# Firmware Release Updates

## IQ2 Smart Controller

**Version 4.05 firmware for the Red Jacket® IQ2 Smart Controller is now available.** The 4.05 version includes important updates that improve STP protection settings to streamline operations.

#### Red Jacket IQ2 Smart Controller

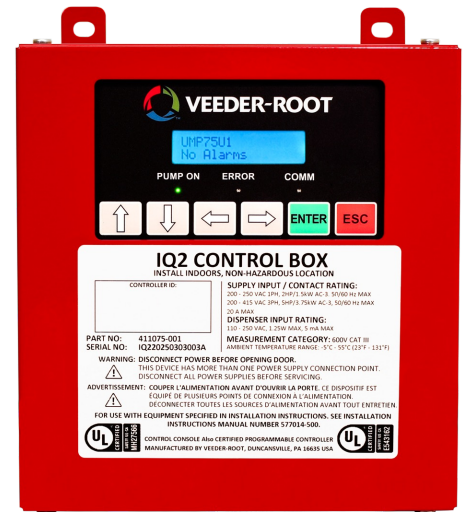
**IQ2 Firmware 4.05** is currently the **minimum version suggested** for any application, and include the following improvements:

- Improved hook switch response.
- Adjusted relay set points for 3phase 50Hz STP with the following UMP:
  - UMP75U17
  - UMP150U17
  - UMP400U17
  - UMP500J17
  - FE STP150C
  - FE STPM200C
